## **CALNET II RFP DGS-2053**

## Question and Answer Set #28 May 24, 2006

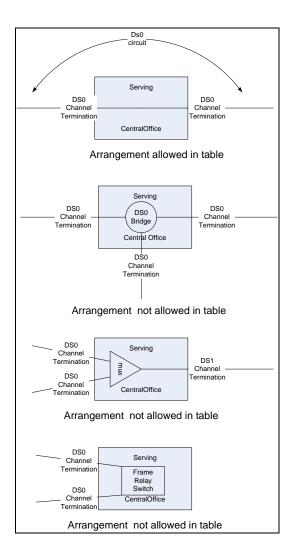
- 197. Table 6.1.3.2.2 calls for DS0 service as described in the explanatory text before the table. The key requirements in the text are:
  - Advanced Digital Network (ADN) or equivalent A dedicated digital private line service at DS0 and below speeds, providing full duplex, 4 wire, end-to-end, synchronous, data transport
  - Subscriber Access Channel termination for the Hi-Cap circuit. One for each termination

The corresponding cost table has a single price entry, and it labeled "price per circuit". This implies that what the State is asking for is a complete circuit.

This price model is simplistic and does not support other configurations that DS0 service is used in. The following diagrams show different arrangements in which the DS0 circuit is used in the current state environment.

The industry commonly uses "channel termination" pricing to allow ds0 circuits to be used in various combinations as shown below. The state's table structure will require bidders to use a higher-cost end-to-end circuit when only a channel termination is needed.

Would the State be willing to replace requirement for end-end circuit with a channel termination, which connects the end-user to the bidder's network?

This will be addressed in a future addendum.
